Monthly Specification Update

Intel® Server Board S5520UR

Intel Order Number E69054-001

May 2011

Figure 1. Removing the Heatsink

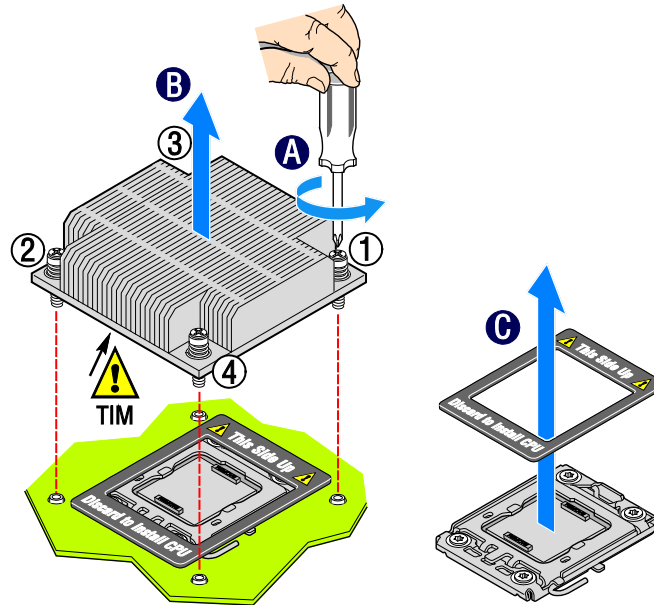
1. Proper Heatsink Installation and Removal Instructions are missing from Service Guide

Problem: The current documentation does not properly describe the installation and removal of the heatsink. Careful insertion and removal of the heatsink is required to prevent damage to the heatsink screws or backplate.

1. Loosen the four captive screws on the heatsink corners in a diagonal manner according to the numbers shown in figure 1 as follows:
 - Starting with the screw at location 1, loosen it by giving it **two rotations** in the anticlockwise direction and stop. (**IMPORTANT:** Do not fully loosen.)
 - Proceed to the screw at location 2 and loosen it by giving it two rotations and stop.
 - Loosen screws at locations 3 and 4 by giving each screw two rotations and then stop.
 - Repeat steps 1a through 1c by giving each screw two rotations each time until all screws are loosened.
2. Do one of the following:
 - If removing the heatsink for the first time, do the following:
 - i. Lift the heatsink from the board.
 - ii. Remove and discard the spacer (see letter “C” in figure 1).
